**TOWN OF DENTON  
4 N. 2<sup>nd</sup> STREET, DENTON, MD 21629**

**CROUSE PARK BULKHEAD REPLACEMENT  
ENGINEERING SERVICES RFP**

**ADDENDUM 01**  
September 23, 2024

**Town of Denton  
Critical Area Map**  
[Amended 3-3-2022 by Ord. No. 729, effective 3-10-2022]

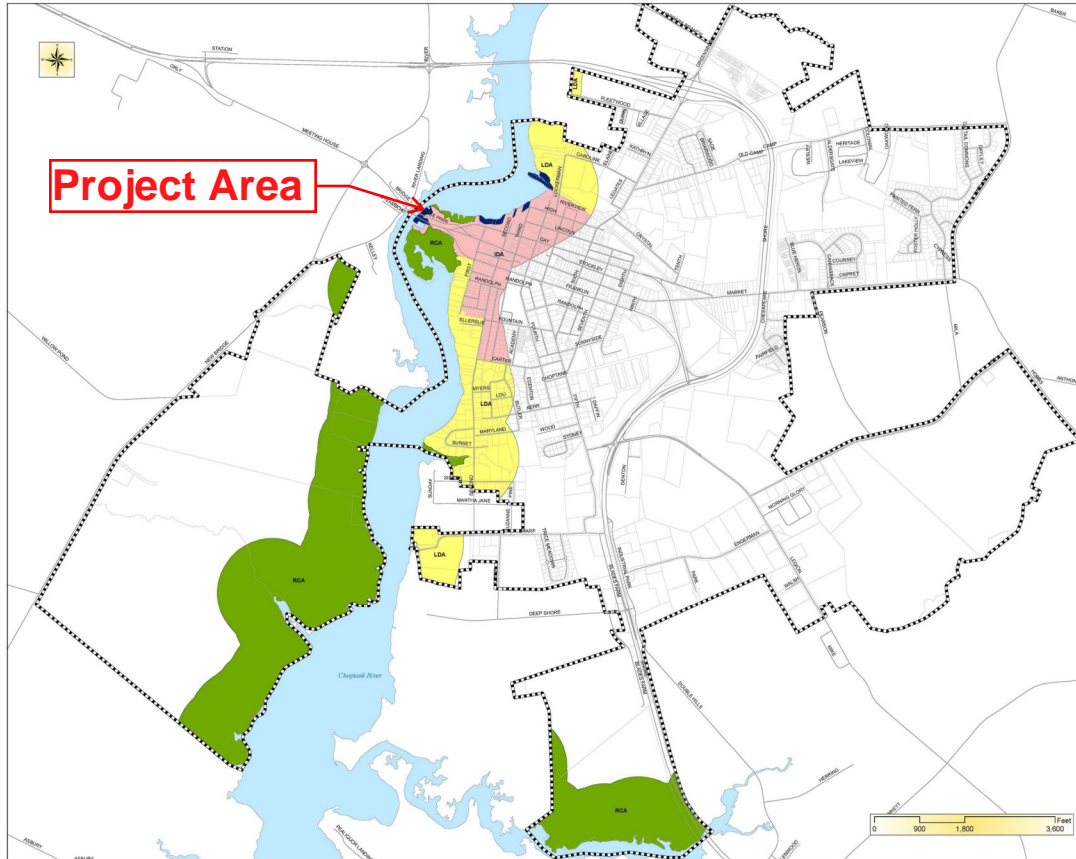
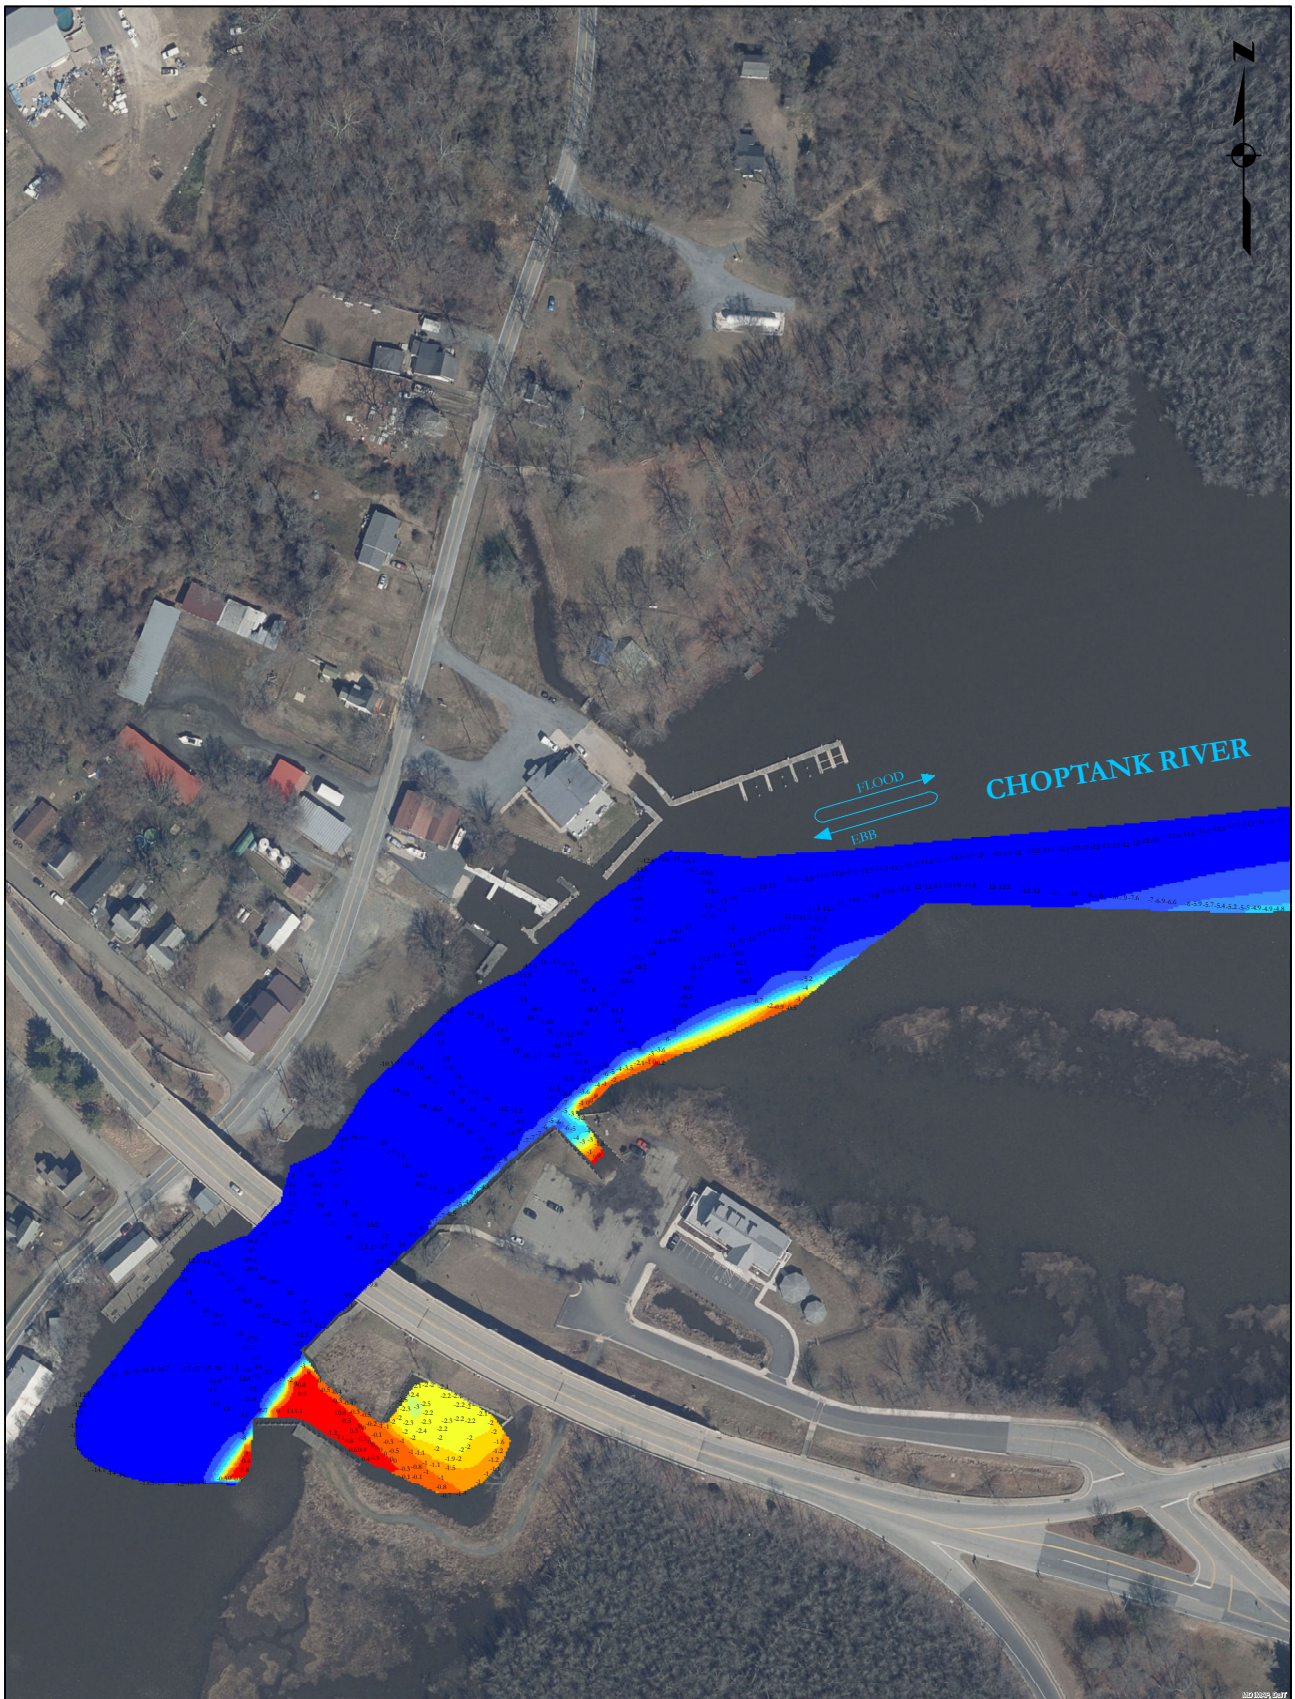
8. **Question:** Is the project area considered to be in an IDA zone?  
**Response:** No, however it is in the Modified Buffer Area (MBA). Reference Town Code Chapter 128 Zoning Attachment 11 Critical Area Map included.

Town of Denton  
Crouse Park Bulkhead Project

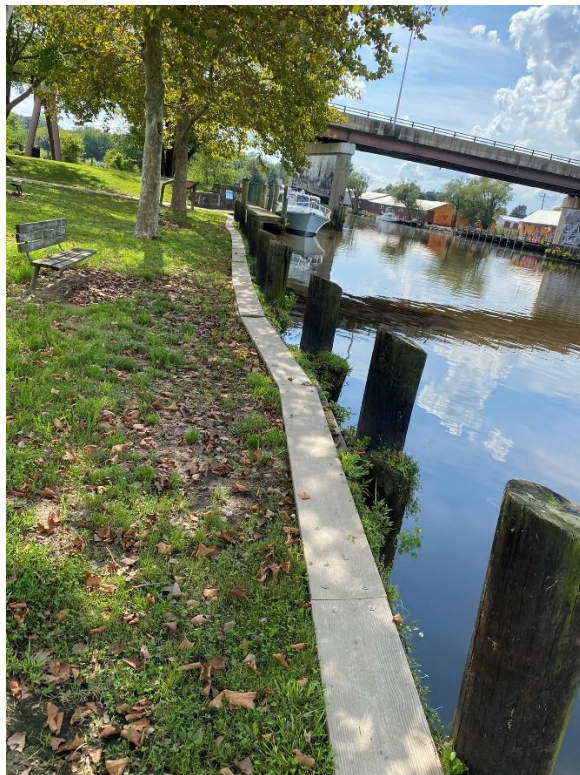
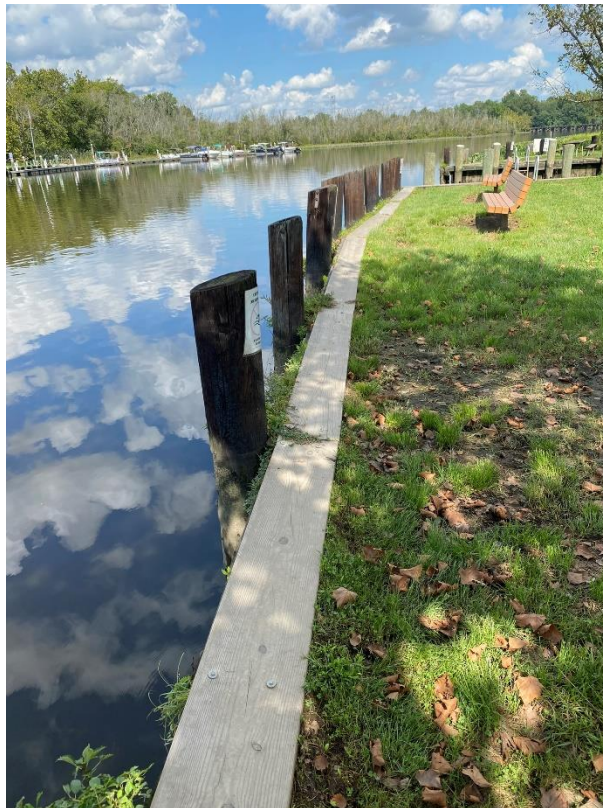
10. **Question:** What is the current condition of the bulkhead? The site was inaccessible prior to the meeting due to the tide.  
**Response:** The existing pilings are not in great condition and do not have caps. Much of the horizontal wood sheeting has rotted away and has holes along the edge. We installed a “cap” along the entire edge to curb erosion. Reference attached pictures.
